Service Bulletin No. SB-AG-22

AILERON HINGE BRACKETS

REASON FOR PUBLICATION: INCREASE FATIGUE LIFE OF THE LOWER AILERON BRACKET ATTACHMENT TO THE WING REAR SPAR.

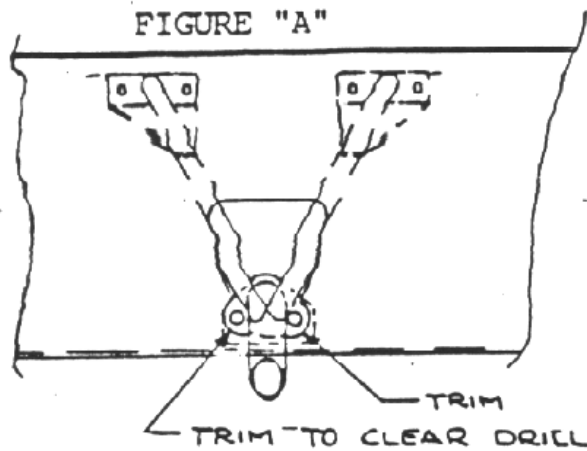
Remove the lower attachment bolts from all six aileron brackets, P/N 52169-1, (There are two lower bolts in each bracket. The original bolts are 3/16 diameter.)

Trim the opening in the aileron bay skin, P/N 20234-1, -2, to permit straight-in drill alignment with the open bolt holes. See Figure A.

Drill out these holes to ¼ inch diameter using a long drill bit.

- 12 ea AN 4-6A Bolts
- 12 ea AN 960-416 Washers
- 12 ea AN 365-428 Nuts
